MIL-C-11693C
 AMENDMENT 5
 15 October 1991
 SUPERSEDING
 AMENDMENT 4
 6 August 1982

MILITARY SPECIFICATION

CAPACITORS, FEED THROUGH, RADIO-INTERFERENCE REDUCTION, AC AND DC
 (HERMETICALLY SEALED IN METAL CASES),
 ESTABLISHED AND NON-ESTABLISHED RELIABILITY
 GENERAL SPECIFICATION FOR

This amendment forms a part of Military Specification MIL-C-11693C,
 dated 8 October 1971, and is approved for use by all Departments
 and Agencies of the Department of Defense.

FIGURE 1. Insulation-resistance curve for characteristics -B, -K, -E, and -H.

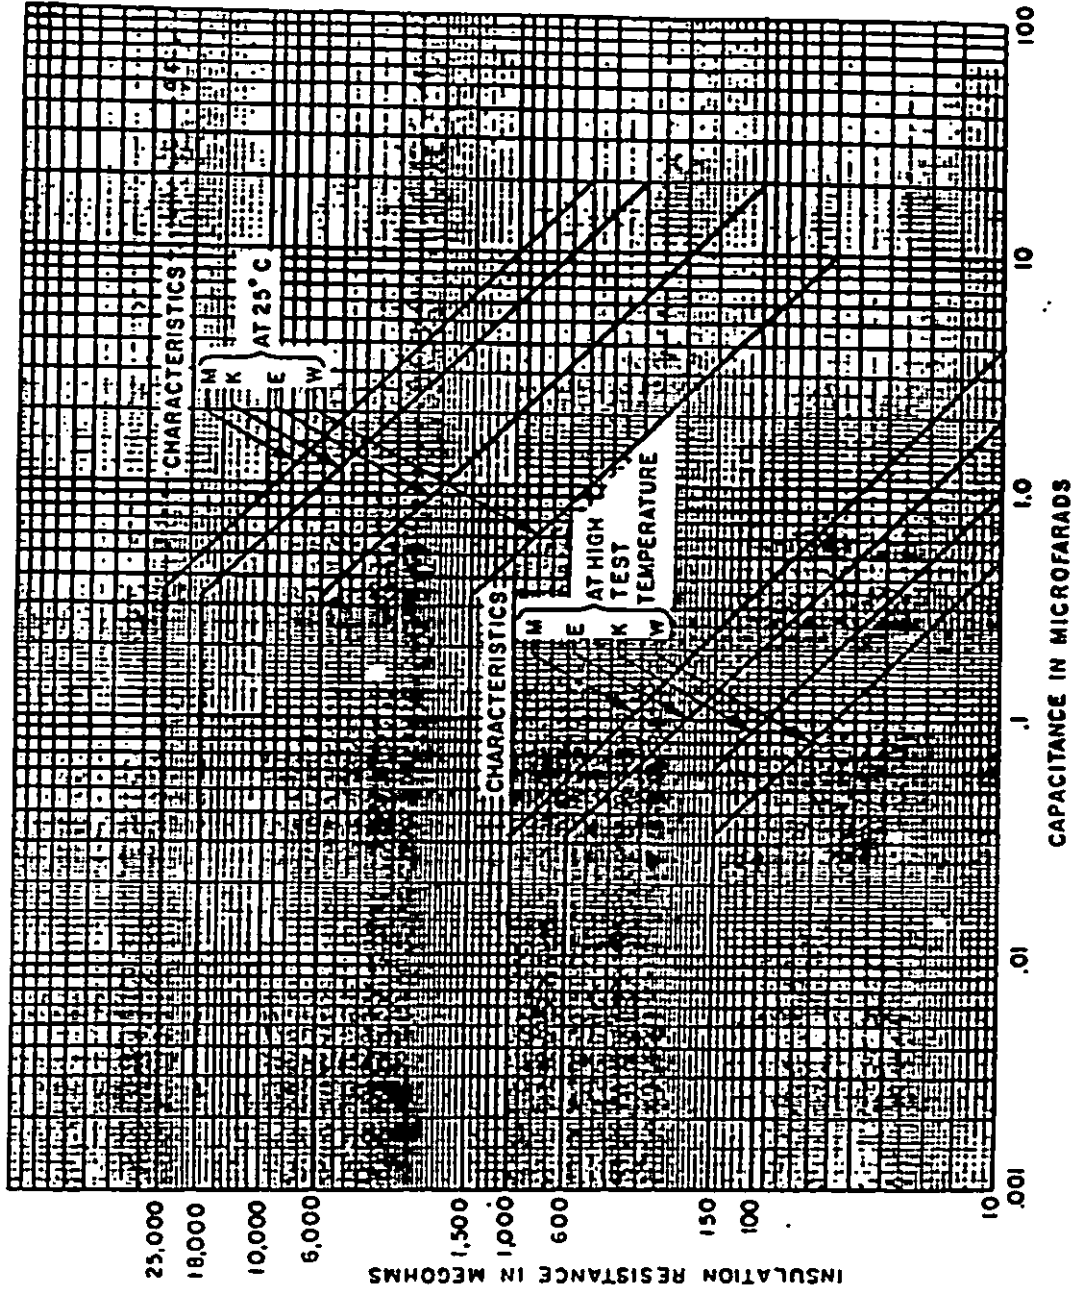
FIGURE 1: Delete and substitute new figure 1 as printed on page 3 of this amendment.
